MP 10_0159 Royal Far West Expansion Concept Plan, Manly

Thank you for your letter of 16 September 2011 requesting comment on the proposed mixed use development at the above address. Sydney Water has reviewed the proposal and provides the following comments for the Department's consideration.

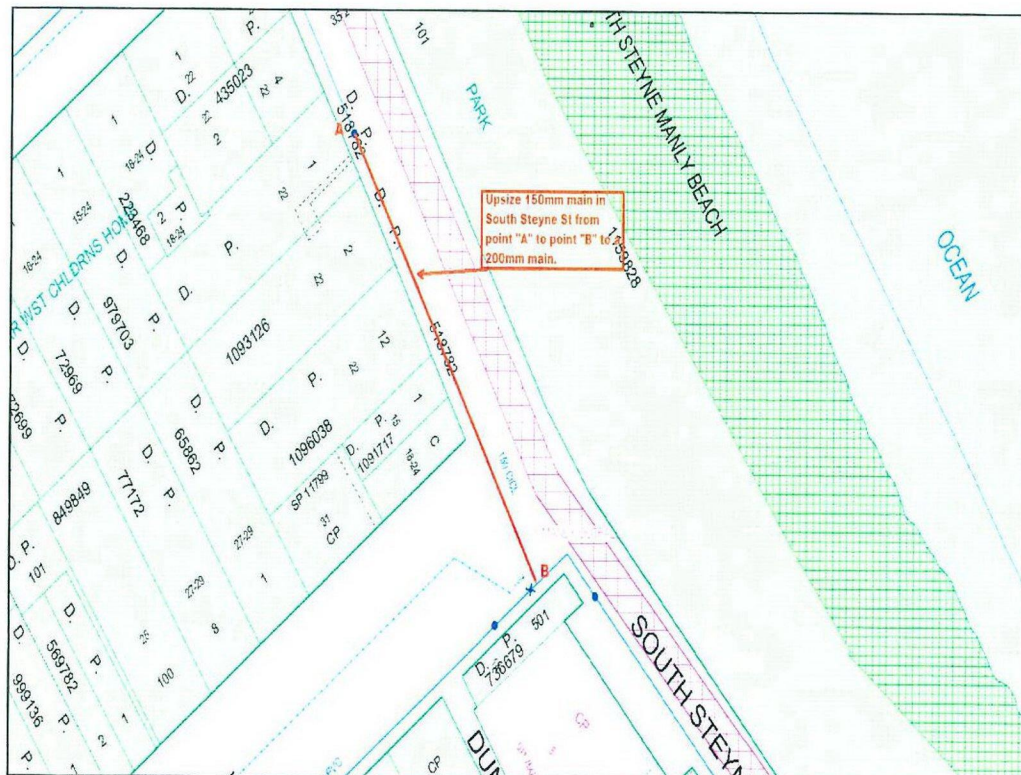
The 150mm drinking water main fronting the proposed development in South Steyne does not comply with the Water Supply Code of Australia (Sydney Water Edition – WSA 03-2002) requirement for minimum sized mains for the scope of development. The drinking water main needs to be upsized to a 200mm main from point 'A' to point 'B' ('B' is 2 metres past the point of connection) as seen in the plan below.
